G-2239-2

Subject: Response to Permit Review Comments, Proposed Townhomes,
3803 NE 155th Street, Lake Forest Park, Washington

LFP Permit File No. 2023-CSD-0002

Reference: Updated Geotechnical Engineering Study, Proposed Townhomes,
3803 NE 155th Street, Lake Forest Park, Washington. GEO Group Northwest,
Inc., October 29, 2021.

EXISTING SITE PLAN

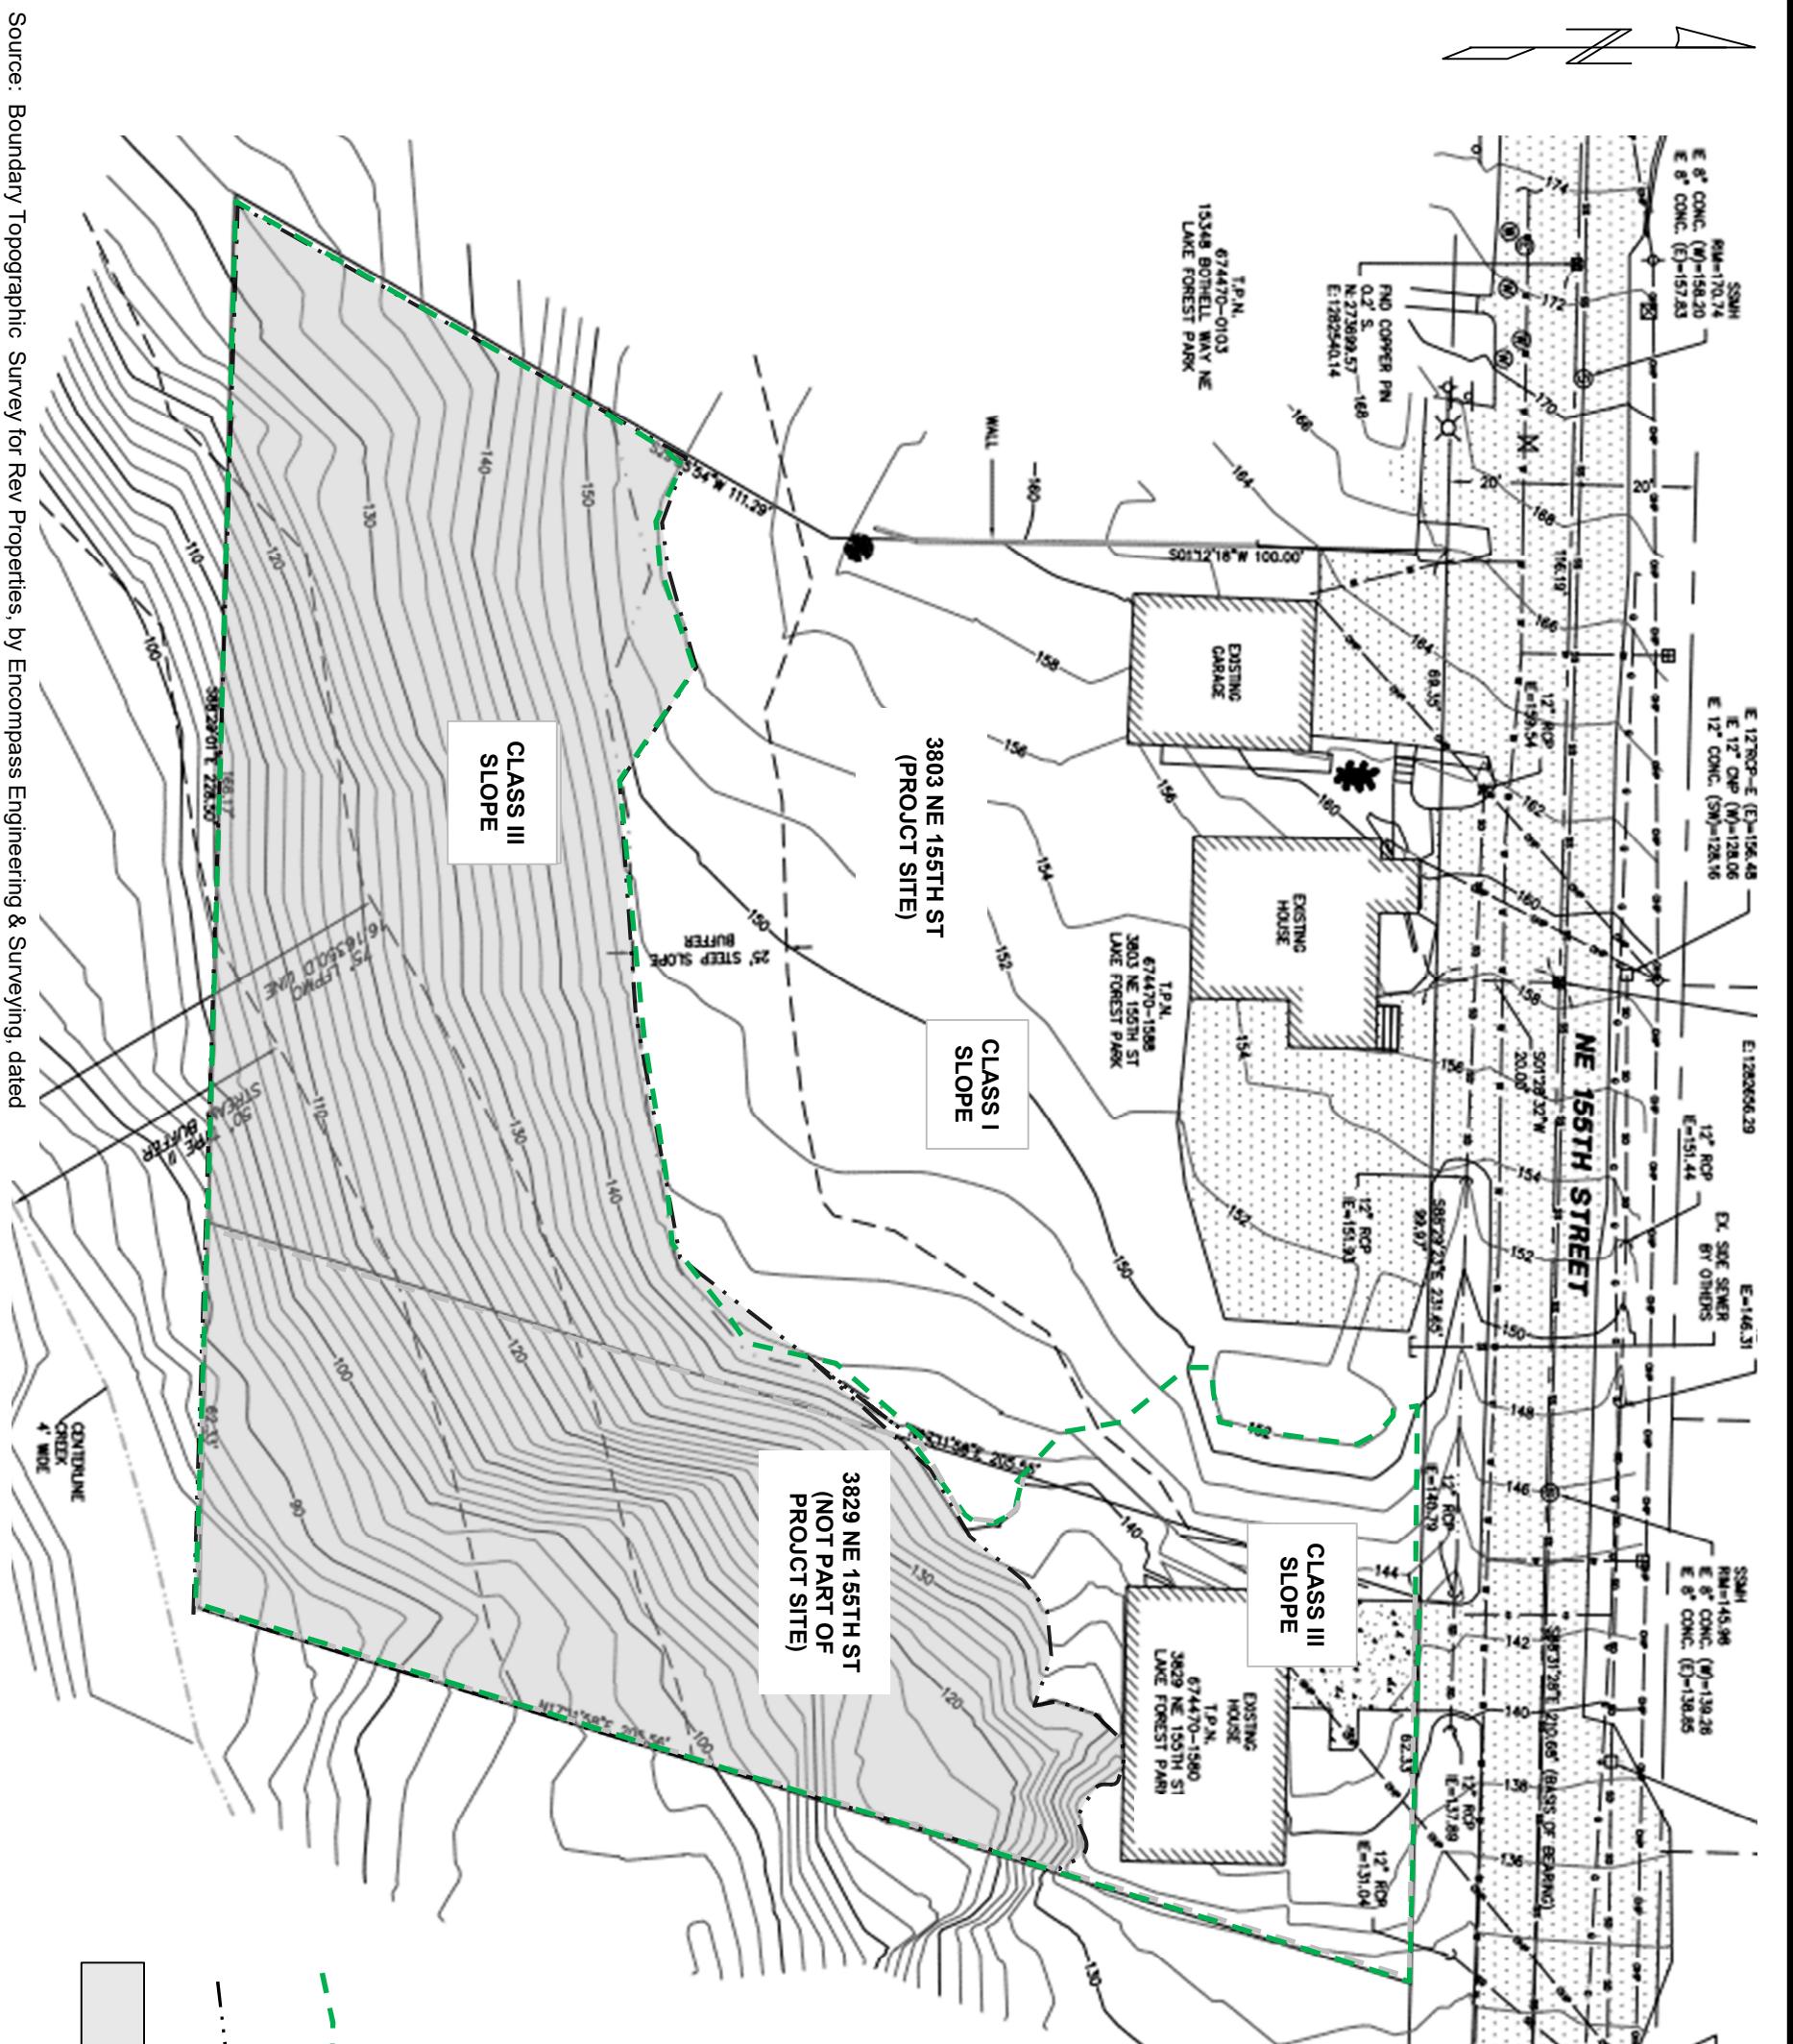
The site plan shows the presence of a steep slope area meeting the characteristics of those types of slopes regulated in LFPMC 16.16.280-310. Please provide a classification of the sloped area pursuant to the definitions in LFPMC 16.16.040

(G), (J), and (W) from a qualified professional (as defined in LFPMC 16.16.040 (Q)).

We have evaluated the topographic information provided in the project plans site for classification of the sloped areas per the definitions stated above. Our classification of these areas is illustrated in Plate 1 – Existing Site Plan and is discussed below.

The portion of the site meeting the criteria for classification as Class I slopes consists of the middle to northern and western part of the site, as illustrated in Plate 1 – Existing Site Plan. This area has slopes of less than 15 percent grade.

The remaining part of the site has slopes meeting the criteria for classification as Class III slopes. The Class III designation is applied to this area because the slope inclinations are greater than 15 percent, and the slopes are underlain with relatively impermeable soils and water seepage that has been noted in our referenced geotechnical report.

The portion of the area with Class III slopes that has inclinations of 40 percent grade or more and 10 feet or more in height is designated a landslide hazard area per the criteria in LFPMC 16.16.040 (J.2.d). The portion of the Class III slope area in the northeast part of the site that does not have inclinations of 40 percent grade or steeper for a height of at least 10 feet does not meet the criteria for being designated as a landslide hazard area per LFPMC 16.16.040 (J.2). As a result of the designations described above, the extent of the landslide hazard area is the same as that of the steep slope area on the site (discussed below), as illustrated in Plate 1 – Existing Site Plan.

The topographic information indicates that a steep slope area per the criteria in LFPMC 16.16.040 (W) is present on the southern and southeastern portion of the site. The top and bottom of the steep slope area typically has distinct breaks in grade at its top and bottom extents.

The steep slope area has a maximum inclination of approximately 80 percent grade and has a maximum height of approximately 70 feet.

Areas that have slopes greater than 15 percent grade meet the criteria for being classified as erosion hazard areas per LFPMC 16.16.040 (G). Therefore, this site area having Class III slopes also is designated as an erosion hazard area.

PROPOSED DEVELOPMENT PLAN

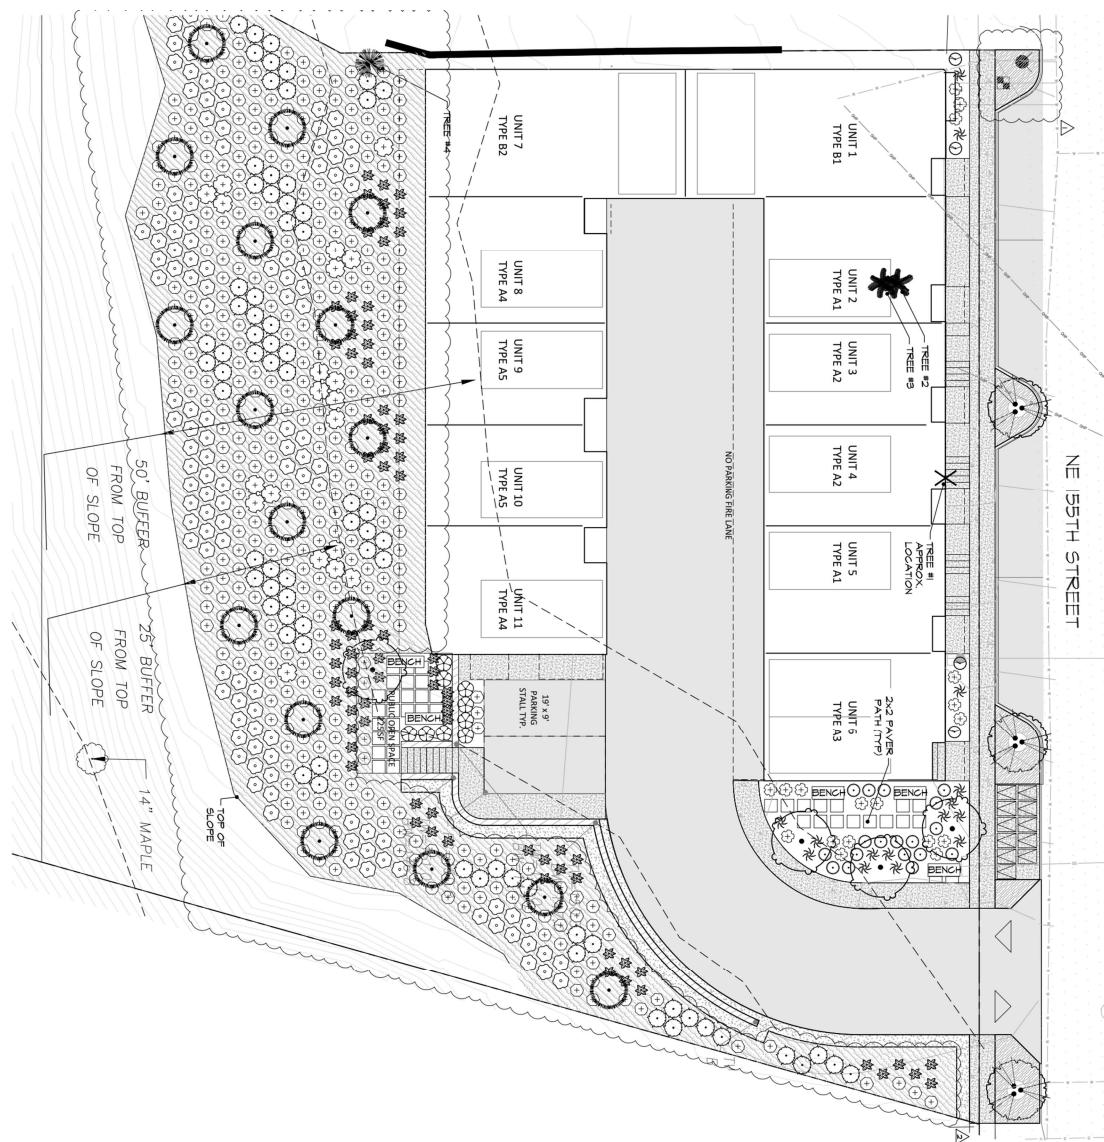
The site plan shows a reduced buffer of 25 feet from the top of the surveyed slope. A reduced buffer is permitted in some cases when a qualified professional determines the area meets the reduction criteria in LFPMC 16.16.290 (A) and LFPMC 16.16.310 (A). Please provide an evaluation of the slope reduction criteria from a qualified professional.

We reviewed the project with regard to the criteria for permitted alterations to steep slope hazard areas as outlined in LFPMC Chapter 16.16.310. Although the proposed project does not encroach into the steep slope area, a portion of the proposed development will extend into the proposed 25 feet steep slope area buffer in the northeast part of the site, as illustrated in Plate 2 – Proposed Site Plan.

The proposed project includes no buildings in the proposed steep slope area buffer. However, retaining walls, a set of stairs, two parking stalls, and paver-surfaced public open space area are proposed south of the driveway and east of the building. These features extend up to 10 feet into the proposed buffer and are located at least 25 and 15 feet away from the top of the steep slope area. The proposed retaining walls in this area will have exposed heights of up to 5 feet.

Development within a portion of the landslide hazard area buffer in the northeastern part of the site is proposed for the project. The proposed activity consists of that described above regarding development in the proposed steep slope area buffer, and does not extend into areas having slopes steeper than 40 percent grade.

- a) Retaining walls to be located in the buffer area should be fully supported on pile and grade beam foundation systems, using either small-diameter pipe piles or drilled concrete piles.
- b) The proposed driveway and parking areas in the buffer should be over-excavated to a depth of two feet below the bottom elevation of the pavement section, and the exposed subgrade should then be compacted in place to a dense condition. The over-excavated area should be backfilled per the recommendations regarding structural fill and pavement support in our referenced geotechnical report.
- c) The proposed development will not decrease slope stability on the site or adjoining properties, provided that the recommendations in our referenced geotechnical report and the recommendations stated above are properly implemented. It also is our conclusion
